GROUP **ELE**	MODEL **2014MY Soul (PS)**
	NUMBER **152**	DATE **September 2018**

TECHNICAL SERVICE BULLETIN

SUBJECT: MULTI-FUNCTION SWITCH REPLACEMENT FOR HEADLAMP FLICKERING

Replacement Procedure:

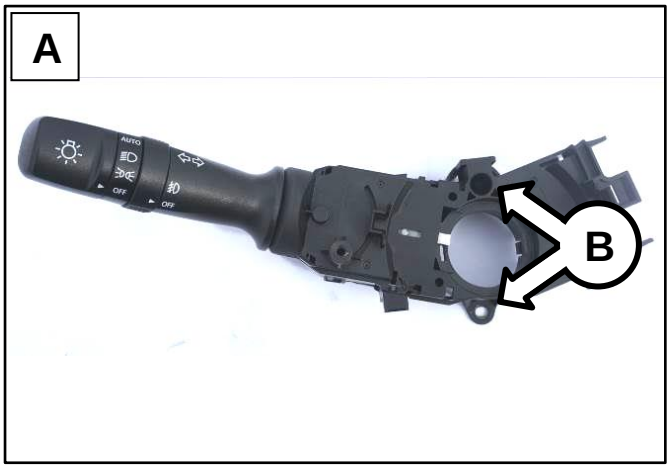
1. Replace the multi-function switch (A) by referring to the “Body Electrical Switch → Multifunction Switch → Repair procedures” chapter in the applicable Shop Manual on KGIS.

Be sure to replace the two (2) multi-function switch retaining screws (part no.: 12290 05121) (B) when installing the new switch (A).
